ADDENDUM 1

CSP 23-27

GYMNASIUM ADDITIONS/IMPROVEMENTS FOR CAVAZOS & TREVINO ELEMENTARY SCHOOLS

ADDENDUM NO: ONE (1)

**INTERIOR
ELEVATIONS**

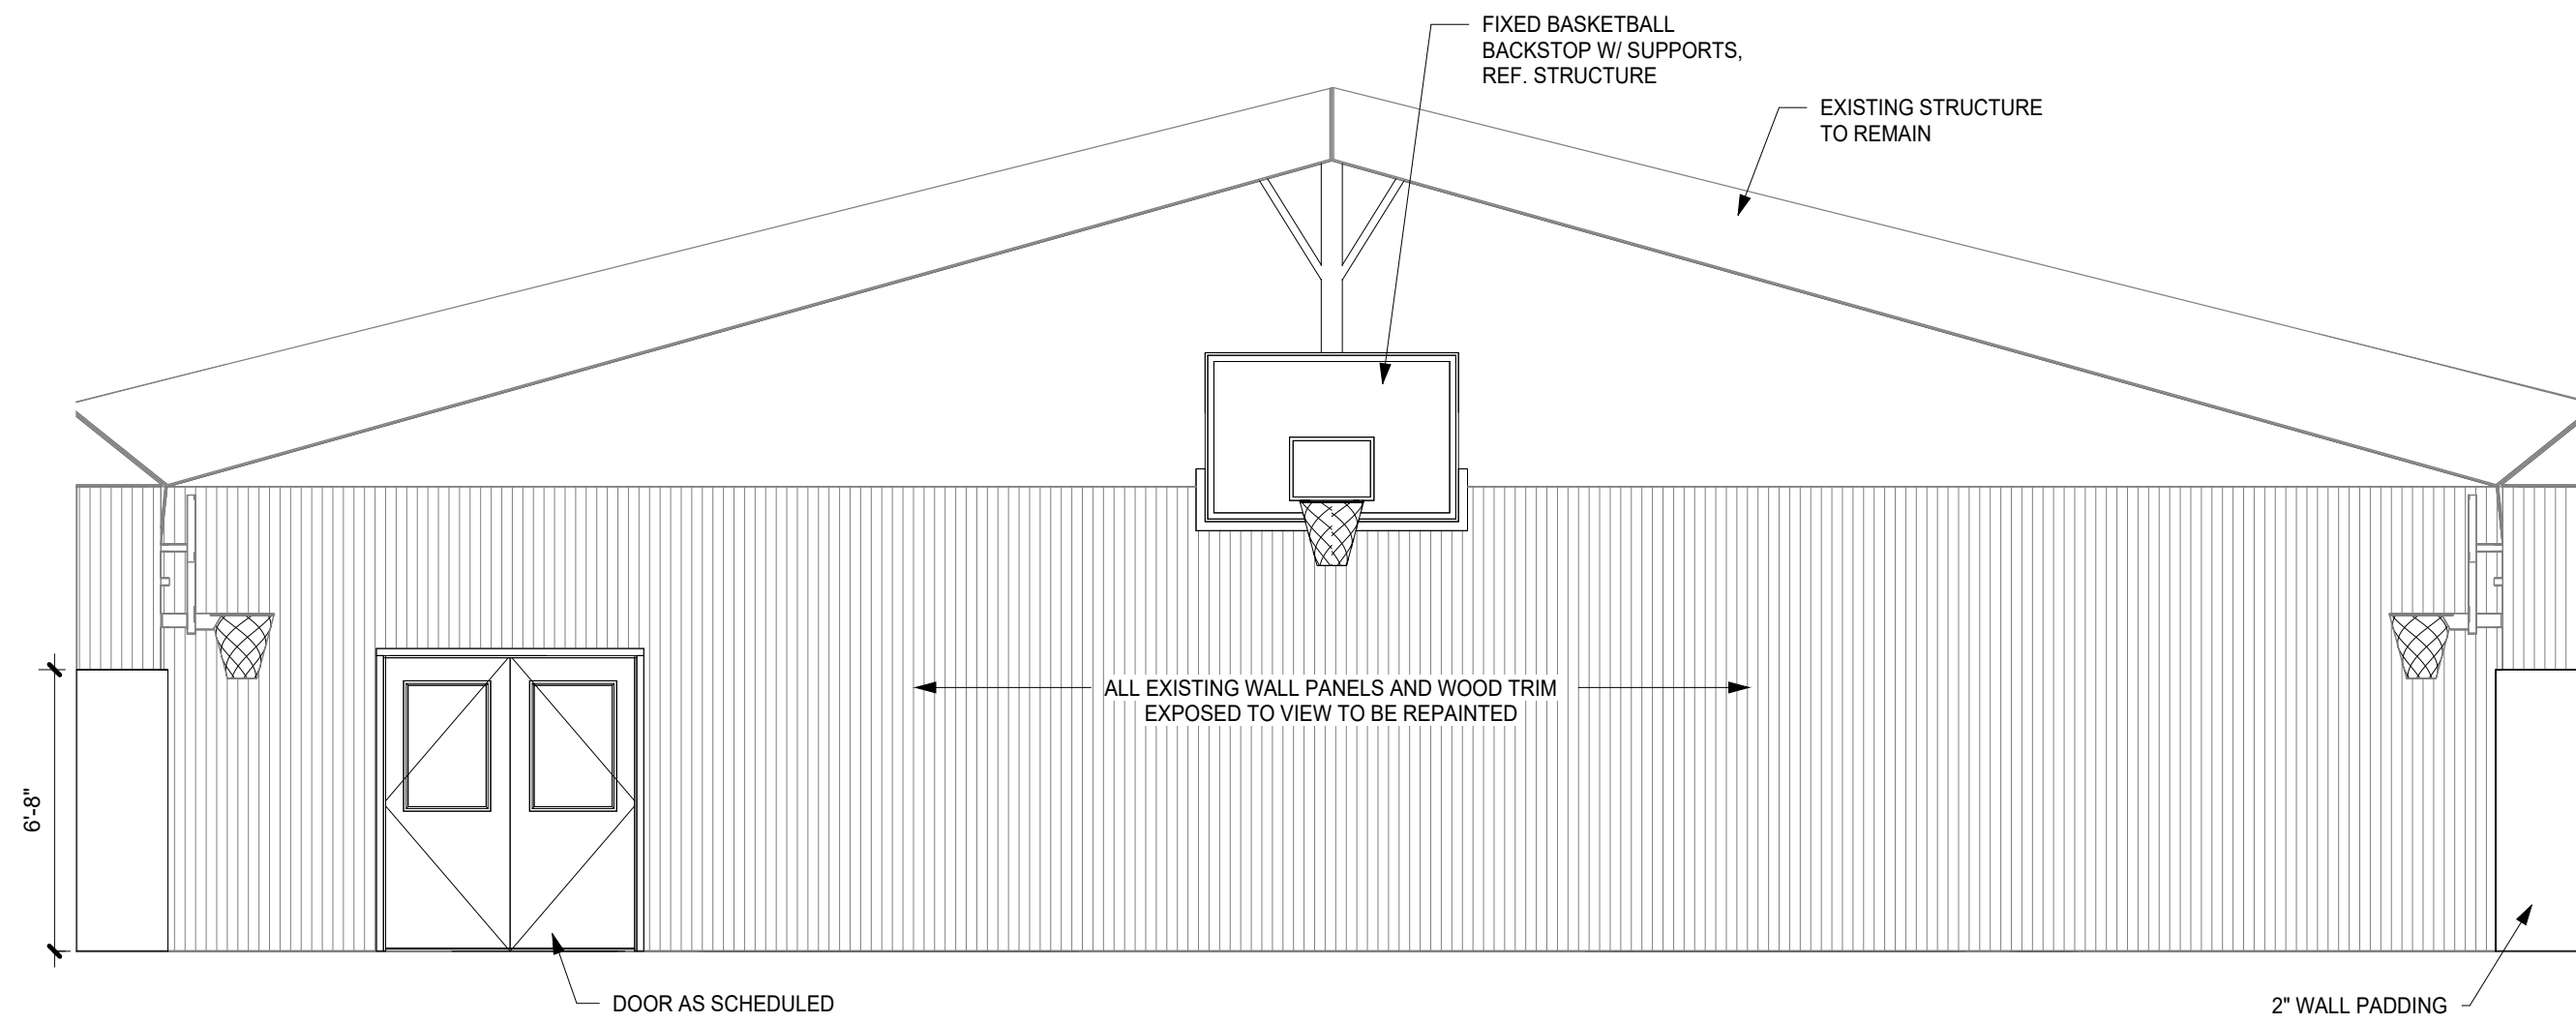
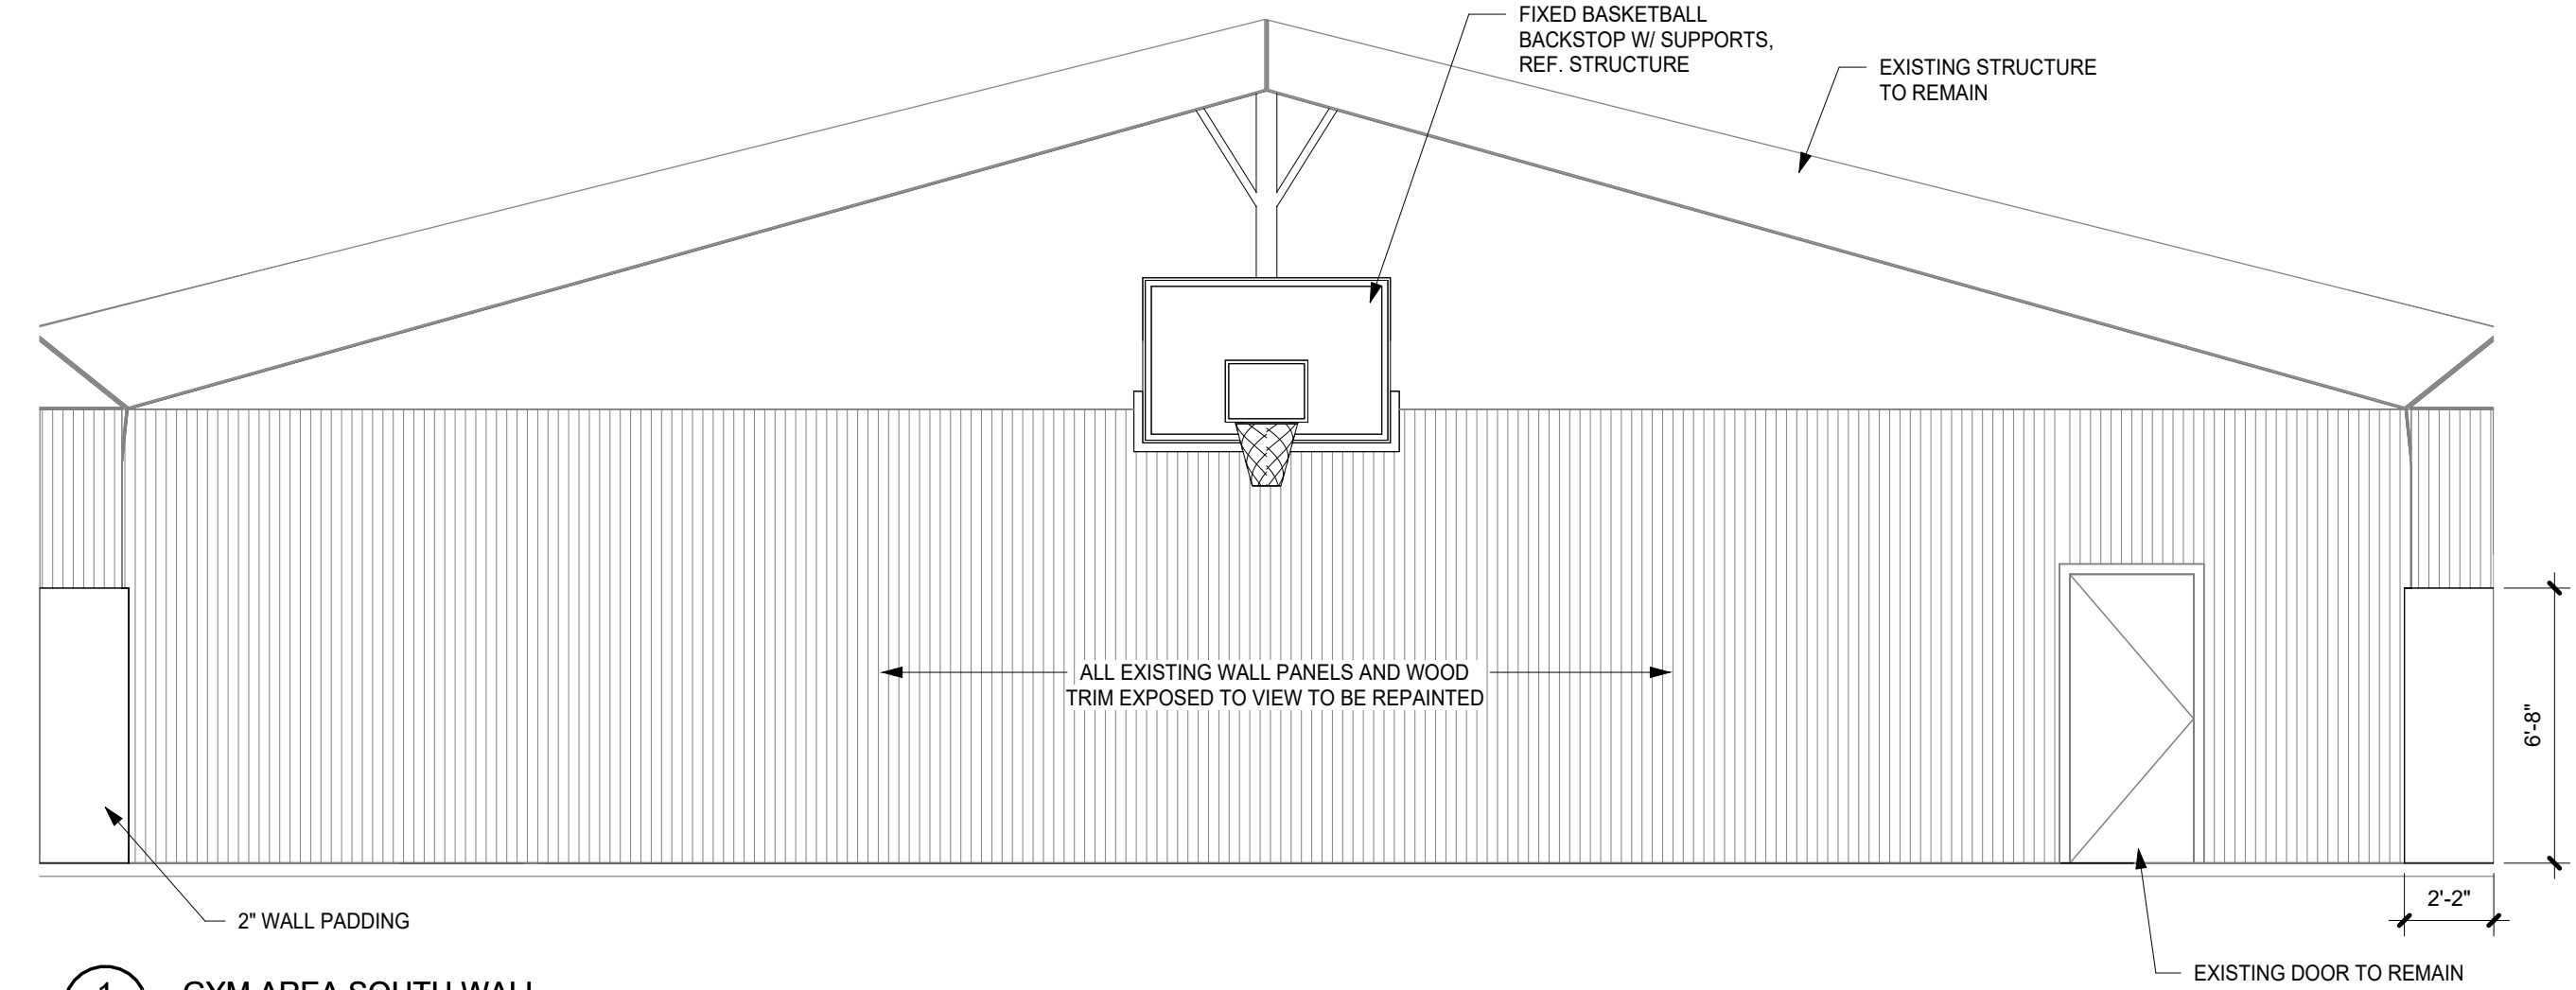
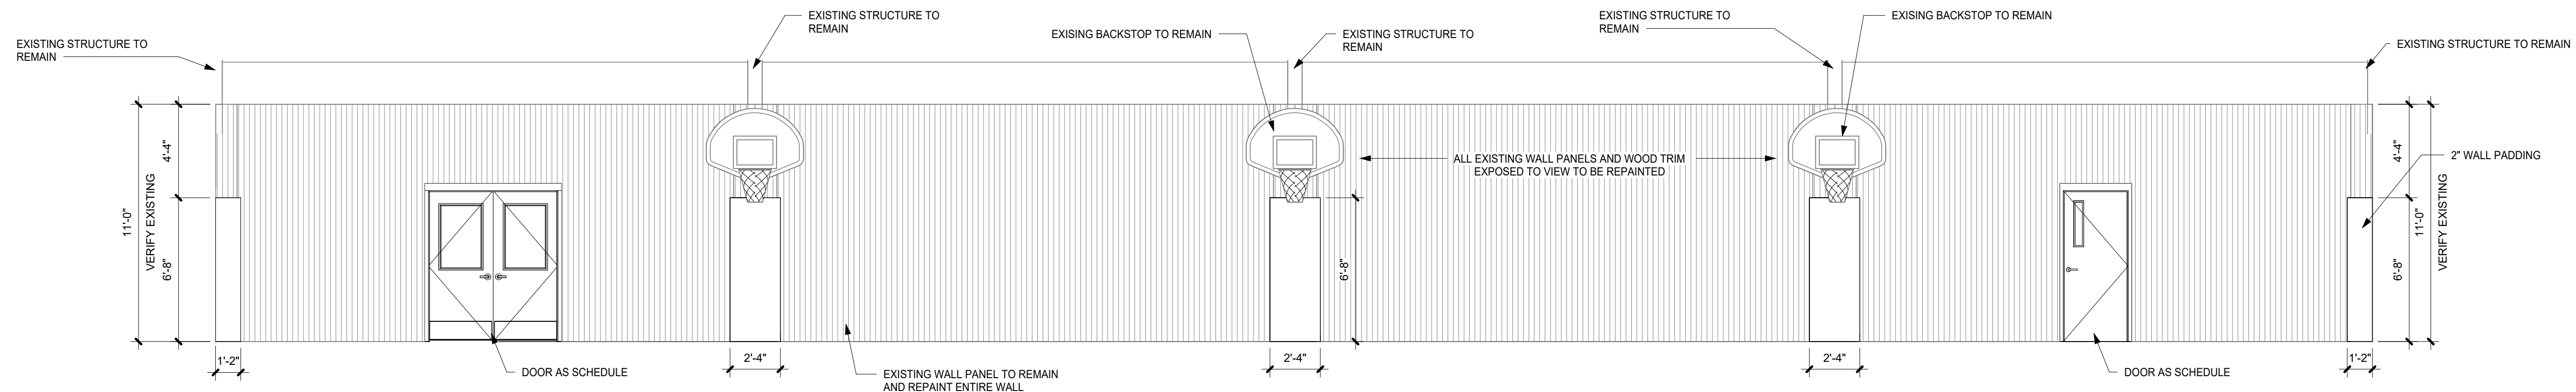
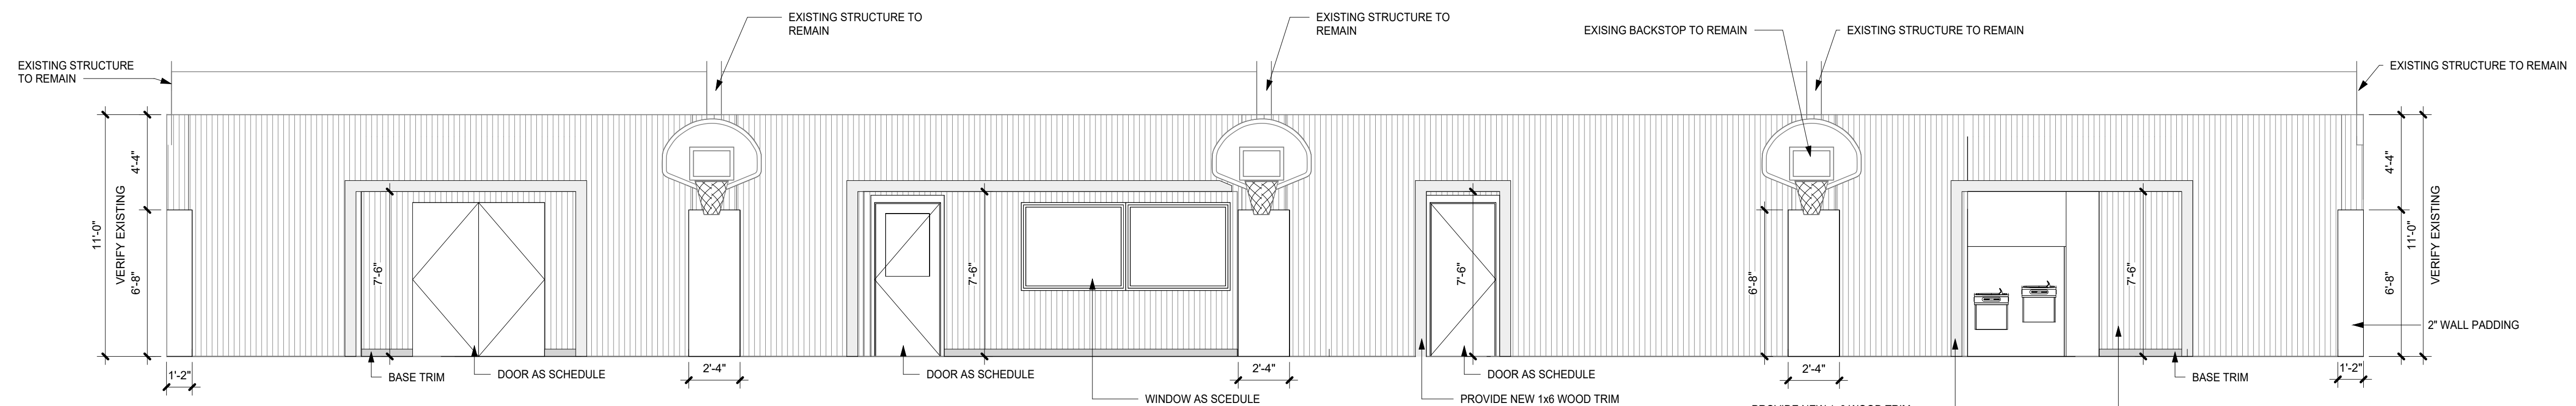
- b. At wall section 4/A4.2 modify wall section as shown and update notes as shown
5. SHEET A5.2 INTERIOR ELEVATIONS (INCLUDED HEREWITH)
 - a. Delete entire sheet A5.2 and replace with sheet A5.2 included herewith

1
E2.0

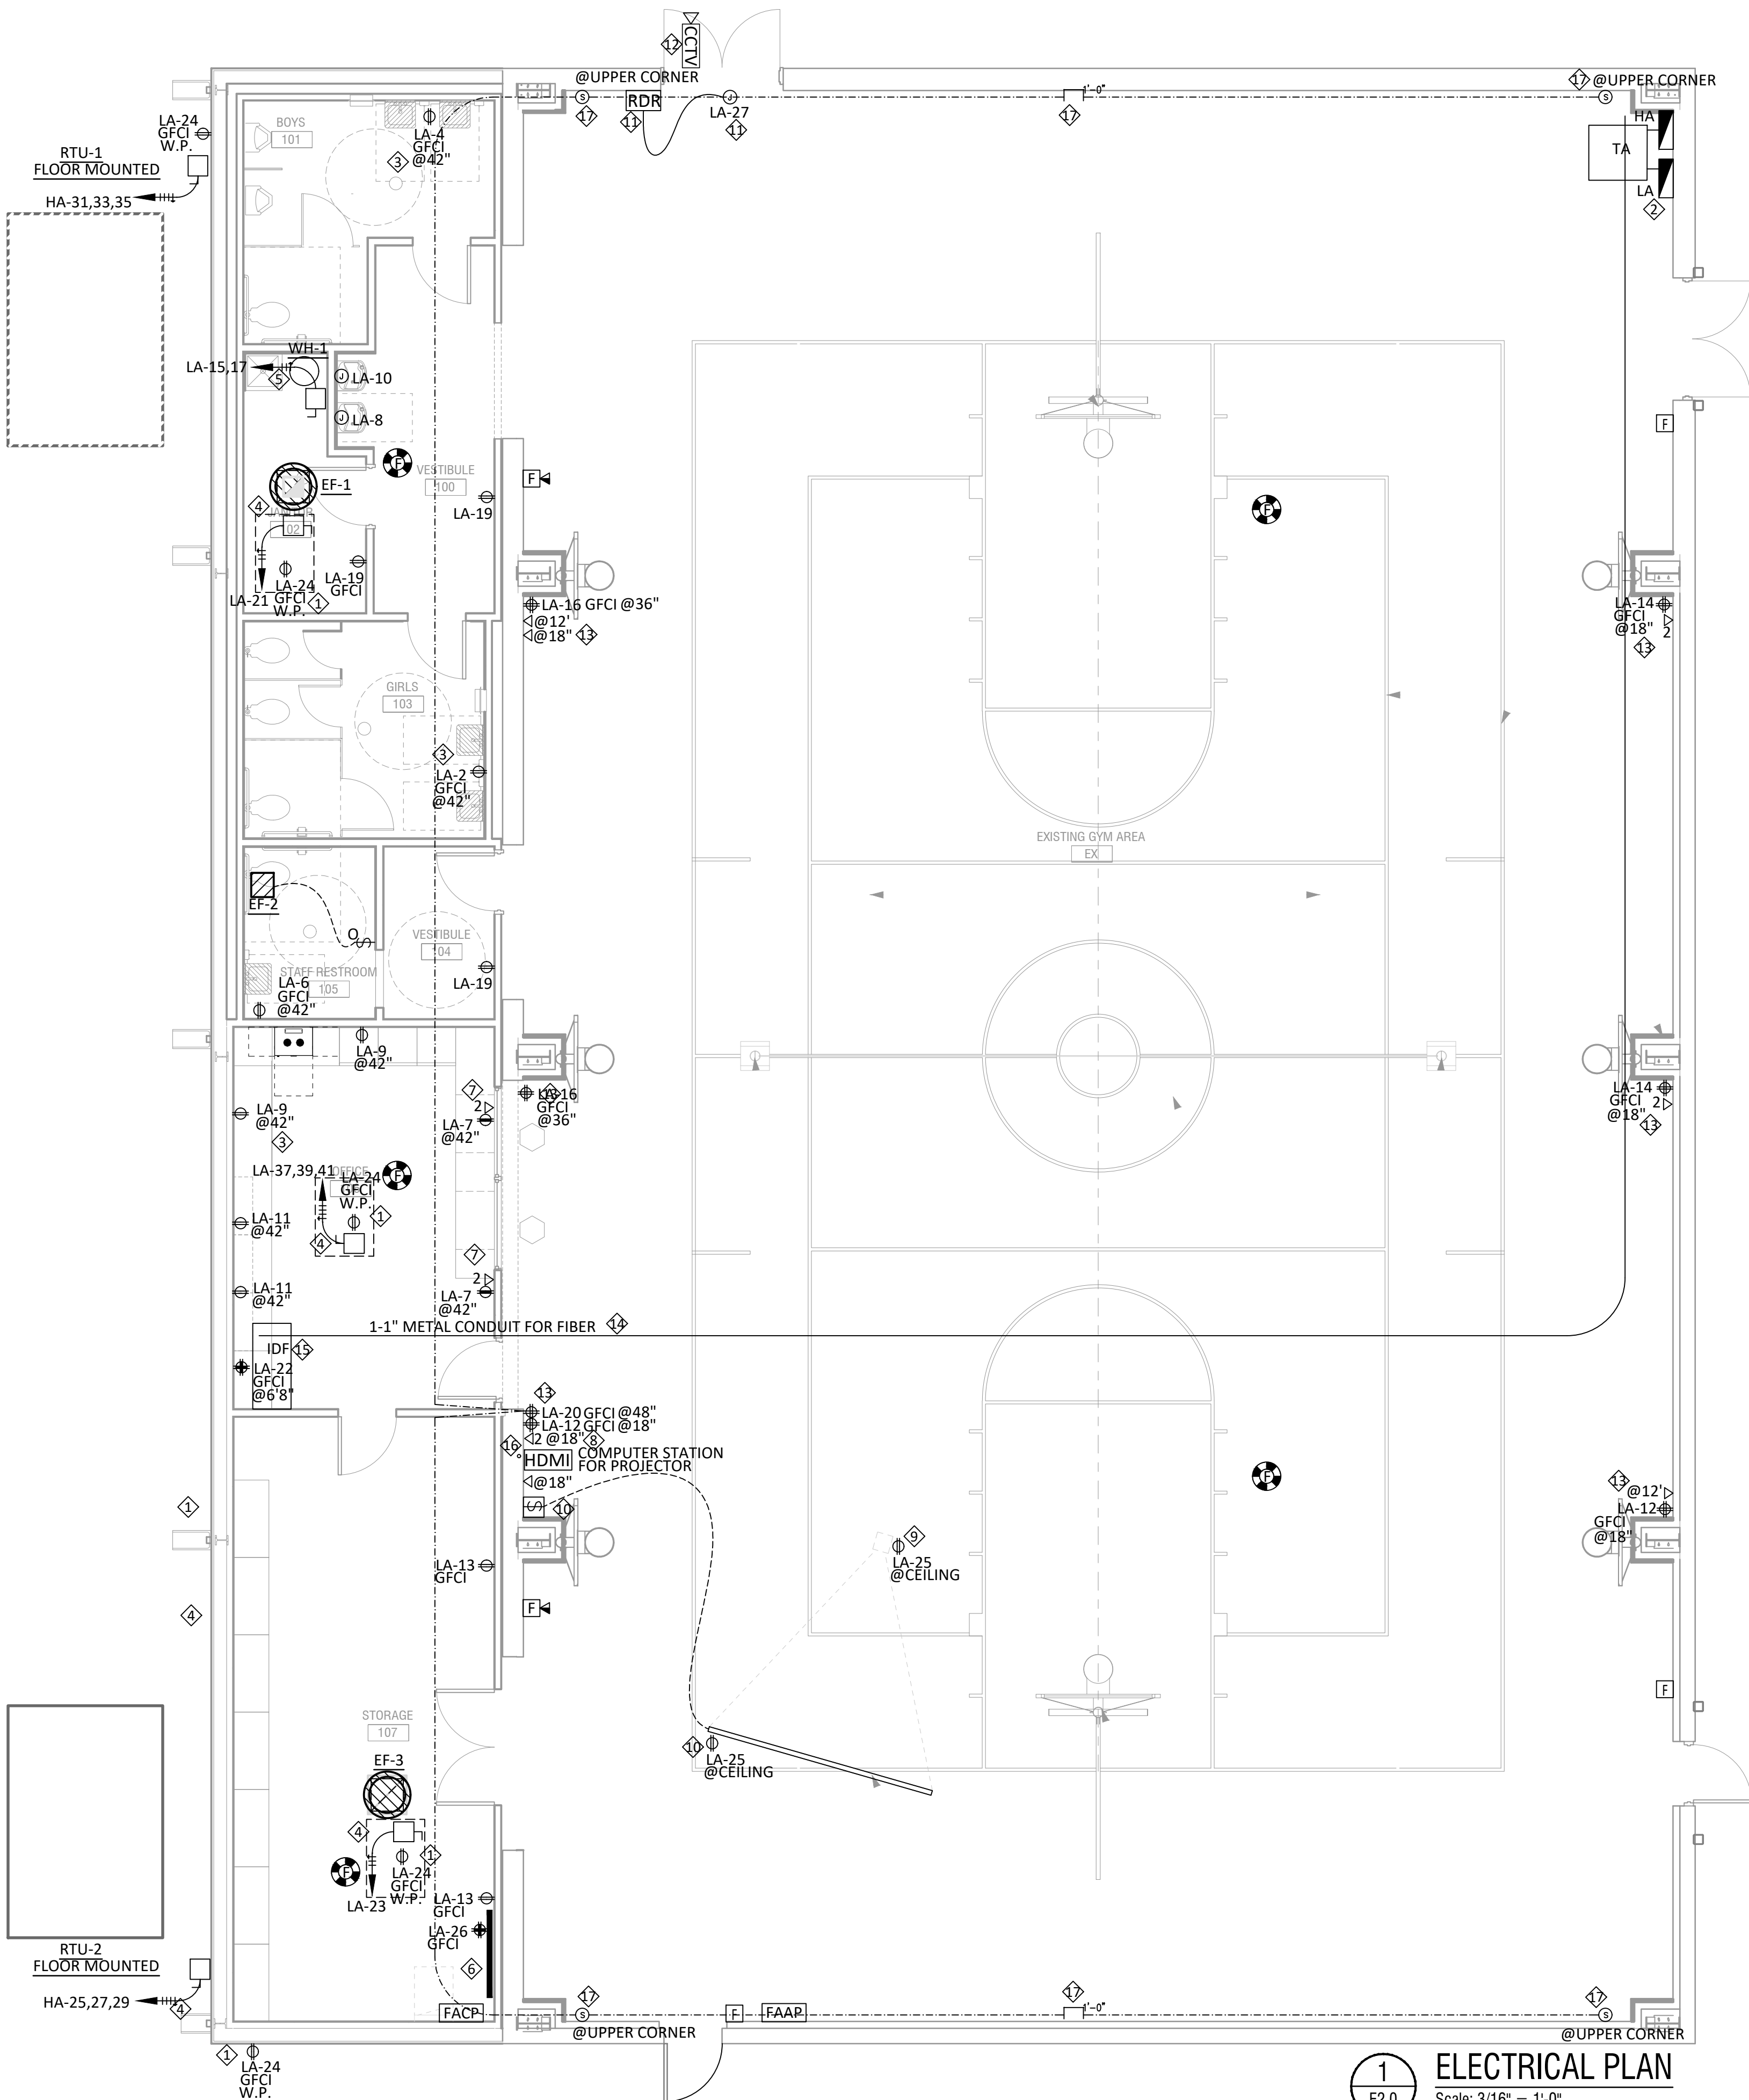
1 – DOOR CLOSURE, SURFACE MOUNTED
7. SHEET E2.0 ELECTRICAL PLAN (INCLUDED HEREWITH)
 - a. Delete entire sheet E2.0 and replace with sheet E2.0 included herewith
 - b. Added circuit for sound
 - c. Added circuit for IDF
 - d. Added pipe for fiber
8. SHEET E3.0 SCHEDULES AND LOADS I
 - a. Panel LA-add 20A breaker to circuit 20 with 1000 watts load for “RECEPT SOUND”
 - b. Panel LA-add 20A breaker to circuit 22 with 1800 watts load for “RECEPT ISO GND IDF”
